SUBJECT: UNIVERSITY OF TEXAS AT AUSTIN - AMENDMENT RE: ADMINISTRATIVE
REQUIREMENTS (TAC NO. MB1361)

AMENDMENT TO FACILITY OPERATING LICENSE

Amendment No. 4
License No. R-129

SAFETY EVALUATION BY THE OFFICE OF NUCLEAR REACTOR REGULATION

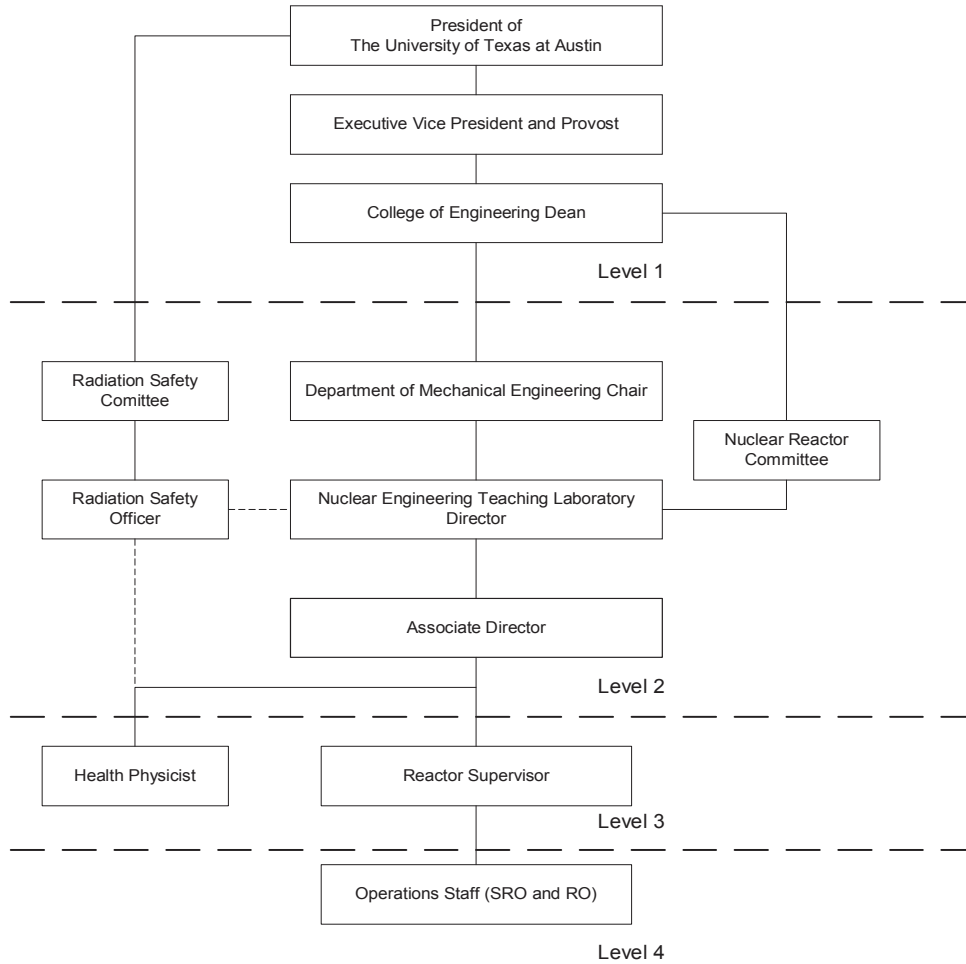
The licensee has also proposed changes to the organizational chart in the TSs to add the position of Associate Director to the organizational chart as a Level 2 manager reporting to the Director of the NETL. The Reactor Supervisor and Health Physicist report to the Associate Director. Management levels at non-power reactors are discussed in the "American National Standard for the Development of Technical Specifications for Research Reactors," ANSI/ANS 15.1-1990 (ANS 15.1). This standard is generally accepted by the NRC staff for the administrative TSs of non-power reactors. The standard states that Level 2 management is responsible for reactor facility operation. The staff concludes that the addition of the Associate Director is in accord with ANS 15.1 and all Level 2 management functions remain at level two. Therefore the addition of an Associate Director to the organizational structure of the NETL is acceptable to the staff.

The Dean of the College of Engineering position on the organizational chart has moved from a Level 2 position to a Level 1 position. ANS 15.1 defines Level 1 positions as those responsible for the reactor facility's licenses. As a member of upper level university management, the Dean of the College of Engineering fits the definition of Level 1 manager and this change is therefore acceptable to the staff. Several minor wording changes were made to the organizational chart (e.g., changing the title "Dean College of Engineering" to "College of Engineering Dean"). The staff has determined that these changes are editorial and do not change the meaning of the TS and are therefore acceptable. These changes were discussed with the licensee during the March 19, 2001, telephone conversation.

The licensee had placed the title "Associate Director/Reactor Administrator" on the organizational chart. During the telephone conversation of March 19, 2001, it was agreed to amend the title to "Associate Director." The licensee had added the title "Reactor Administrator" to the proposed organizational chart to match a sample organizational chart presented in ANS 15.1. The standard points out that the titles in the chart are given as examples only. This change deletes a meaningless title in the proposed organizational chart and is acceptable to the staff.

The facility shall be under the control of the Director, Associate Director or a delegated Senior Reactor Operator. The management for operation of the facility shall consist of the organizational structure as follows:

Responsibility >>>
 Communication ---
